Environmental Report for the State of North Dakota Tract

Township 156 North, Range 102 West, Section 16, Williams County, North Dakota

From: [Haupt, Michael L.](#)
To: [William McCarthy](#)
Cc: [Katie Schmidt](#)
Subject: RE: ROW#5813 - Plains Pipeline - proposed oil gathering pipeline - E2 16-156-102 Williams County
Date: Monday, July 11, 2011 7:16:28 AM
Attachments: [156-102-16WIL.pdf](#)

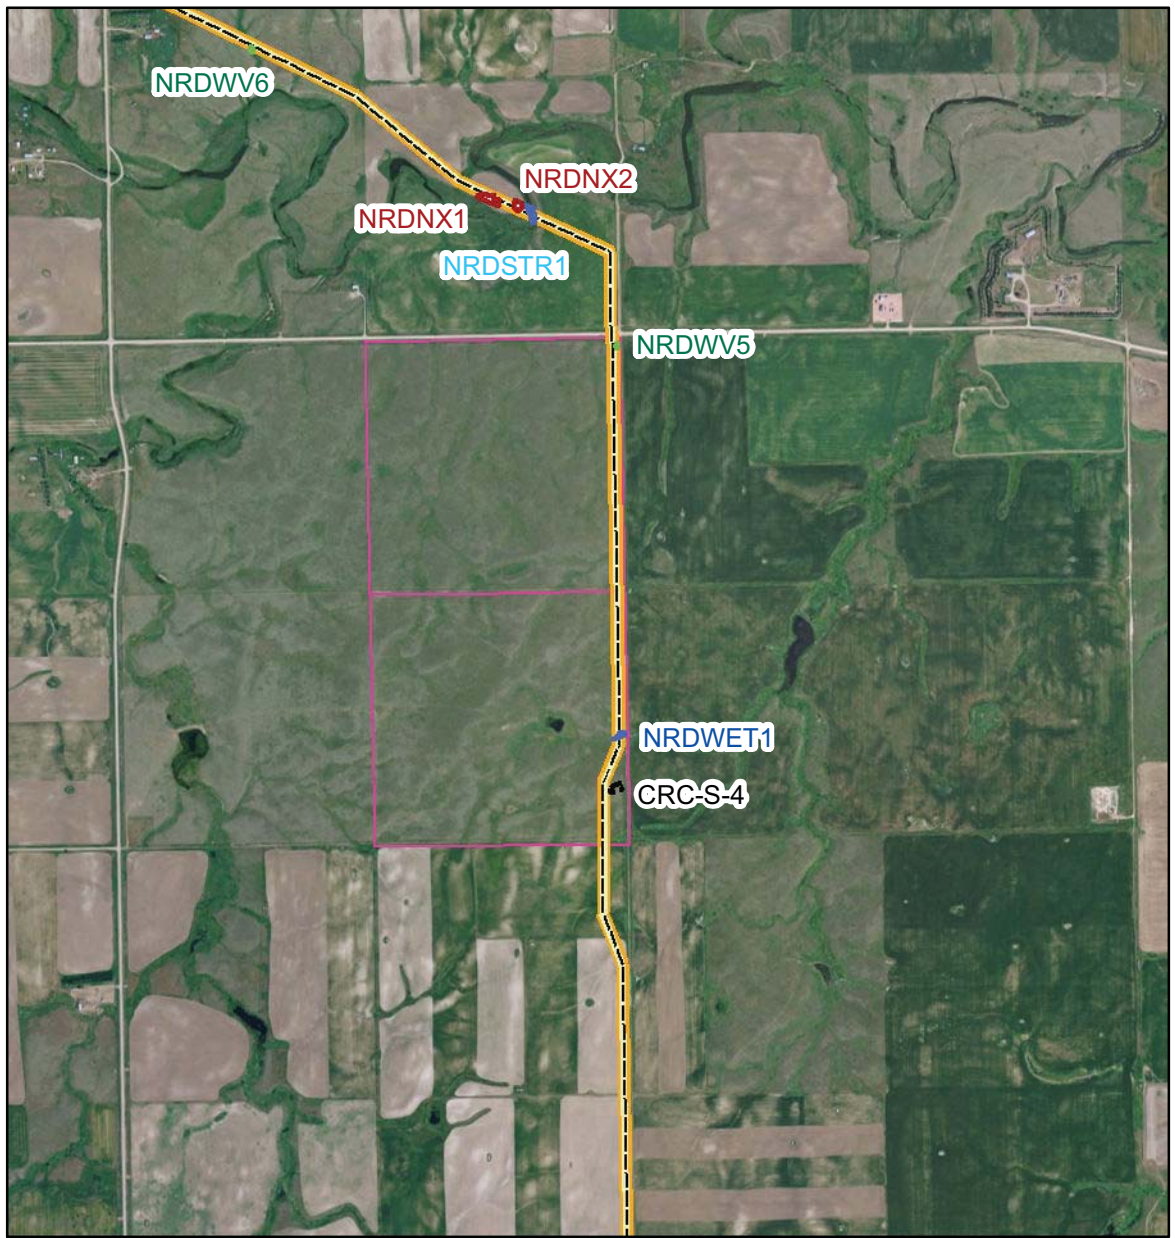
Good morning! The proposed reroute is not acceptable. The centerline of the proposed Plains Pipeline across the E2 of this tract remains at 76 feet west of and parallel to the east section line. We are waiting for the survey plat in order to proceed. Thanks.

Mike, for your review attached environmental report. Is our proposed route acceptable?
Thanks, Toby
